Access Compliance Report

Public Rights-of-Way

(Curb Ramps)

Intersection ID: 18049	Main Street: COLONY_RD	Cross Street: NORMANDY_RD	Location: NE
ADA ID: B9D6863C0164	Ramp Type: ParaDiag	Initial Pass/Fail: Fail	Overall Compliance: No
Severity Score: 1.25			
Codes/Mitigation Info/Possible Solution		Field Measurements/Component Compliance

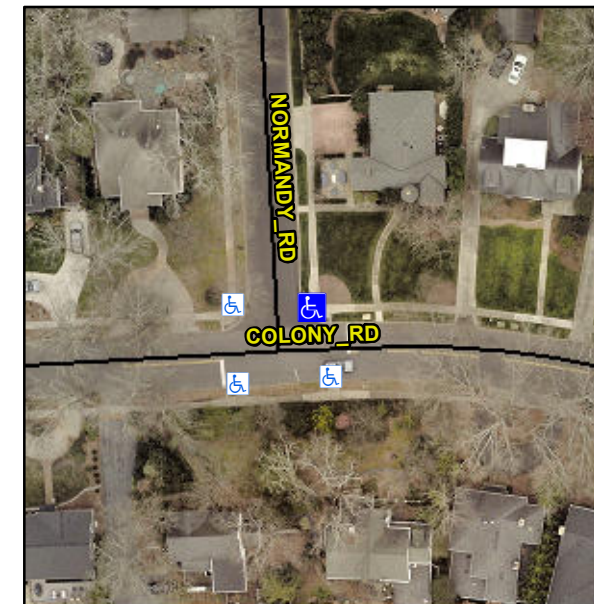
R304.5.3

Compliance	Description	Data	Compliance	Description	Data
N/A	Ramp Length LT (in)	117.0	N/A	Ramp Length RT (in)	106.0
Yes	Ramp Width LT (in)	59.5	Yes	Ramp Width RT (in)	50.0
Yes	Ramp Slope LT (%)	6.1	Yes	Ramp Slope RT (%)	5.9
No	Ramp XSlope LT (%)	2.9	No	Ramp XSlope RT (%)	3.3
N/A	Landing Length (in)	N/A	N/A	DWS Provided?	N/A
N/A	Landing Width (in)	N/A	N/A	DWS Contrast?	N/A
N/A	Landing Slope (%)	N/A	N/A	DWS Length (in)	N/A
N/A	Landing X Slope (%)	N/A	N/A	DWS Full Width?	N/A
N/A	Landing Curb? (Y/N)	N/A	N/A	DWS Offset (in)	N/A
N/A	Shared Landing?	N/A			
N/A	Gutter Ponding?	N/A	N/A	Gutter Slope (%)	N/A
N/A	Gutter Lip Ht (in)	N/A	N/A	Gutter X Slope (%)	N/A
N/A	Painted X Walk1?	No	N/A	Painted X Walk2?	No
	X Walk 1 Direction	To W		X Walk 2 Direction	To S
N/A	X Walk 1 Width (in)	N/A	N/A	X Walk 2 Width (in)	N/A
	X Walk 1 Slope (%)	6.3		X Walk 2 Slope (%)	5.6
	X Walk 1 X Slope (%)	3.0		X Walk 2 X Slope (%)	1.2
N/A	Ramp inside XWalk1?	N/A	N/A	Ramp inside XWalk2?	N/A

Road Slope (%)	2.8	N/A	Clear Space?	N/A
	Road X Slope (%)	0.3	N/A	Clear Space to XWalk (in)	N/A
N/A	Any Obstructions?	N/A	N/A	Storm Grate/Utility Hazard?	N/A
	Obstruction Type			Storm Grate/Utility Type	
		N/A			N/A
			Yes	Surface Condition? (G/P)	Good
			N/A	Curb Slope (%)	7.3

Remove & Replace Curb Ramp With Two New Directional Ramps or Equivalent.
